**Town of Gorham
Planning Board Meeting
October 2, 2023**

ITEM 6 – Discussion – Subdivision Pre-Application – Gary and Megan Jordan – Waterhouse Road - a request for approval of a 16 lot, 24 unit subdivision on Waterhouse Road. Map 18, Lot 5. Zoned UREXP. The applicant is represented by Austin G. Fagan, P.E. with BH2M.

**Gary and Megan Jordan – Waterhouse Road
Pre-application Subdivision Review
M18 L5**

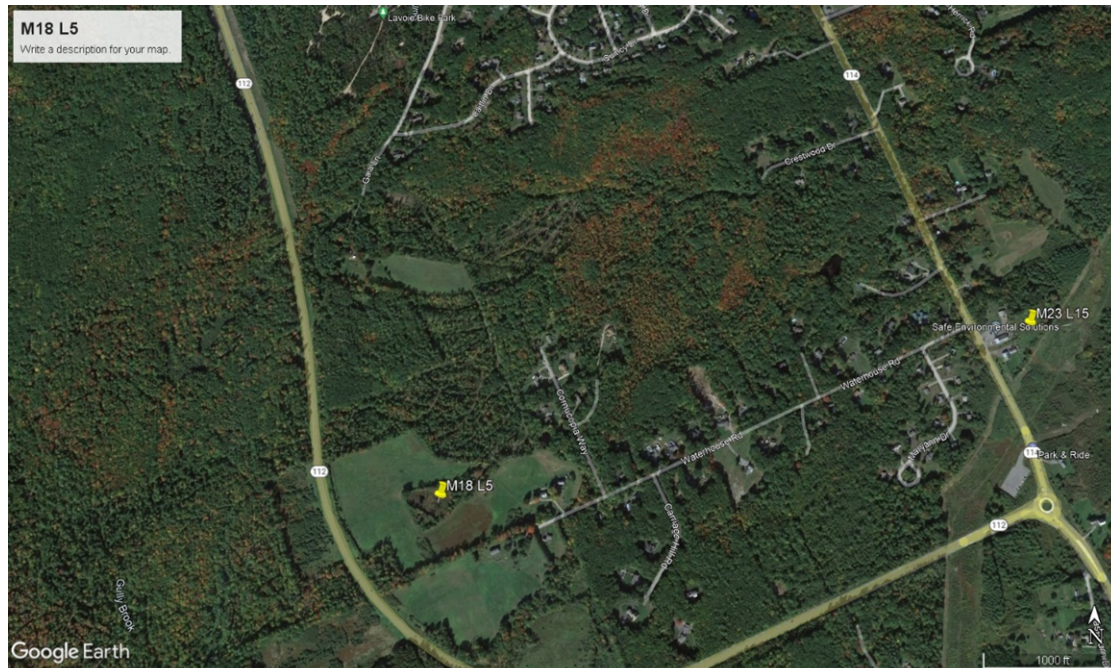
- Community Development staff recommend the water and sewer be provided via Caitlyn Drive due to the reduced linear feet to the project.
- The applicant should work with Portland Water District regarding provision of public water.

Grid pattern of development example in Gorham Village

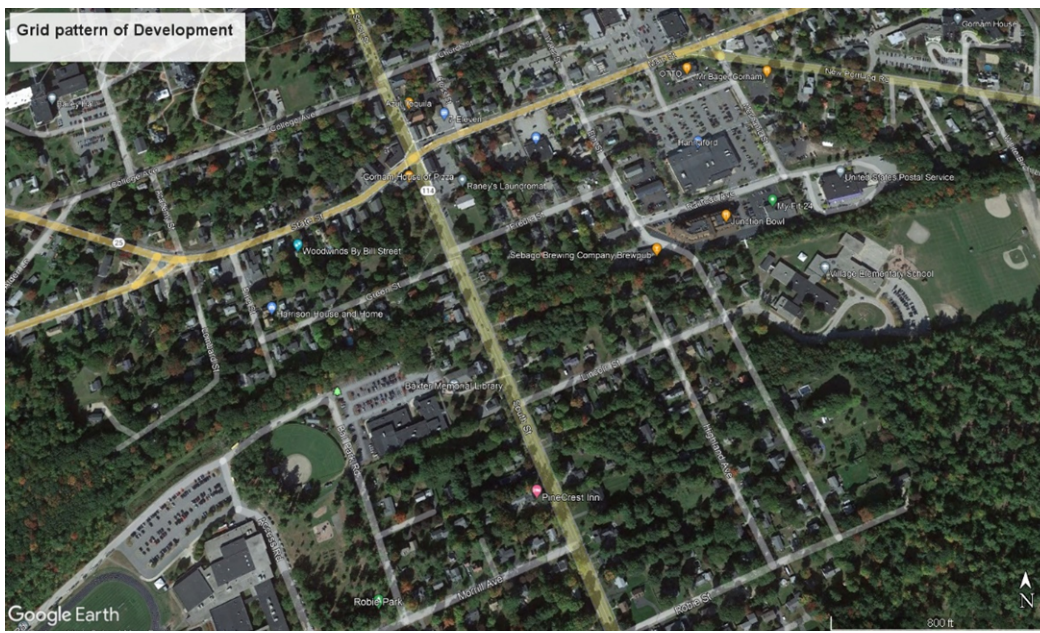
1. The water estimate needs to be calculated according to the ordinance requirements.
2. The water and sewer should be considered to be run from Caitlyn Drive.
3. The owners of the parcel needs to be updated on the plans to show all the owners.
4. Staff recommends that the streets be designed to be public with connections to abutting parcels in a grid pattern as required by ordinance. The grid pattern can be found in the current Gorham village. The length of streets ideally are a maximum of 300 to 400 feet long and are broken up by intersections. The grid pattern does several things: 1. It creates high value per acre 2. It disperses traffic. 3. It allows for walkable neighborhoods. Walkable doesn't only mean a sidewalk; it also means small street lengths and smaller lot frontages.
5. The applicant chooses to use or not to use any overlay type development.
